MFN 09-106

Request for Additional Information Response for the PRIME Model for Analysis of Fuel Rod Thermal – Mechanical Performance

NEDC-33256P – Technical Basis

Figure 1-5: FRAPCON3 Fuel Swelling Model[1-1]

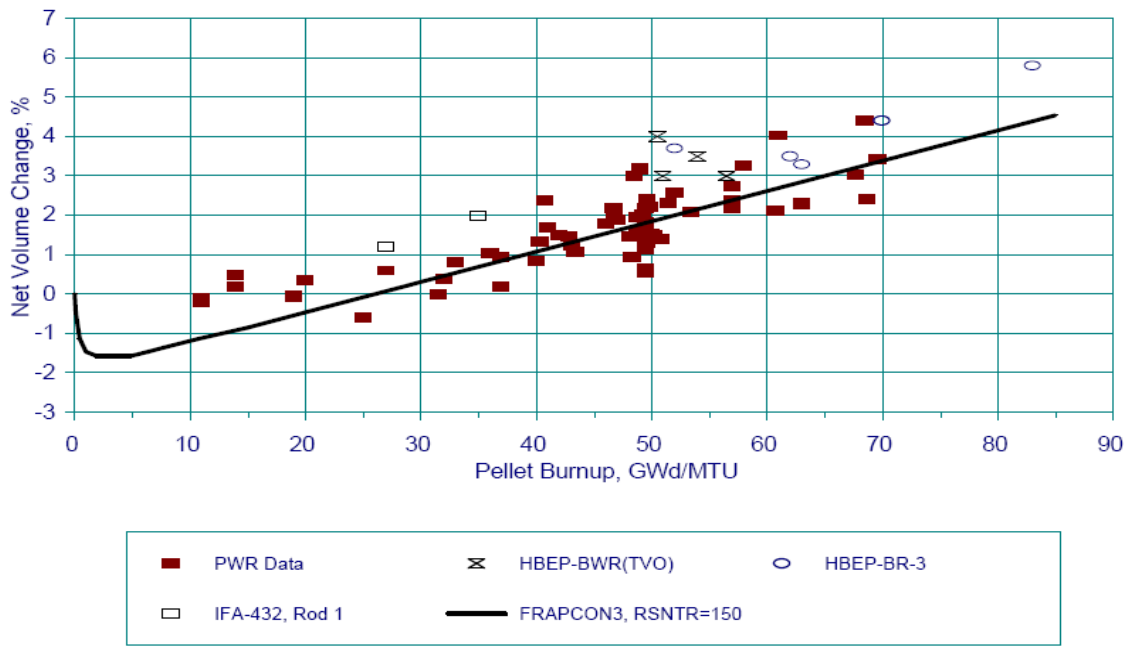
]] New GNF data as summarized in Figure 1-4 of Attachment 1 suggests that for burnup greater than [[
